Adaptive Management Stakeholder Committee of the Edwards Aquifer Habitat Conservation Plan

Adaptive Management Stakeholder Committee Report: Nonroutine Adaptive Management Proposal to Substitute the Sedimentation Ponds Prescribed in the EAHCP for the Minimizing Impacts of Contaminated Runoff Measure

March 16, 2017

Figure 1

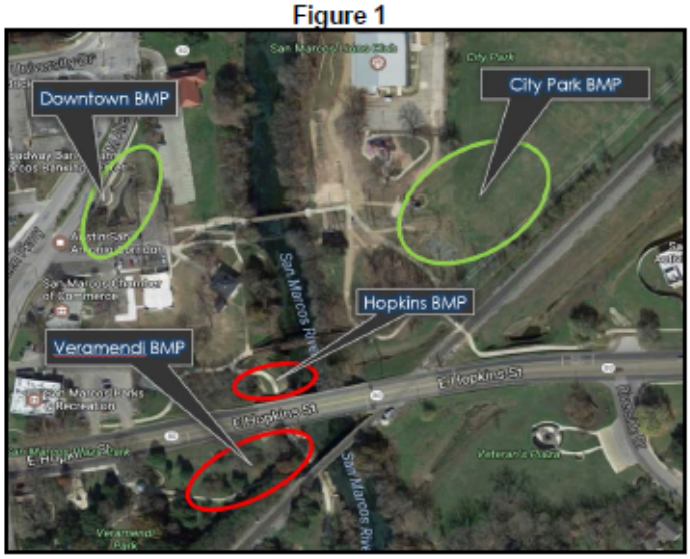
- ***Site constraints***
  The Committee expressed concern that the runoff capture efficiency for the Downtown Pond relative to the downtown catchment area is low, but understands that for this particular BMP, the site is highly constrained and thus is limited in attaining a higher capture efficiency on its own; for this reason, the Committee is highly supportive of future initiatives to be undertaken by the City of San Marcos to increase additional BMP actions within this downtown catchment area in order to mitigate the impacts of contaminated stormwater runoff from downtown.

- *Mr. Mozier asked whether the Downtown and Hopkins ponds shared the same drainage; Mr. Gleason replied that they do not.*
    - *Ms. Jackie Poole asked about the rationale for moving the Hopkins comparison across the river. Mr. Gleason explained that of the original Hopkins measures in the HCP, one is entirely replaced by the City Park Pond (the northern "Hopkins ditch") and the other is unfeasible (the southern "Hopkins ditch").*

- *Dr. Lamon asked the runoff capture efficiencies for each of the various ponds. Mr. Lee Sherman (a subcontractor to John Gleason LLC in the project) replied that City Park (99%), Hopkins 1 (81%), Veramendi (87%), and Downtown (36%).*
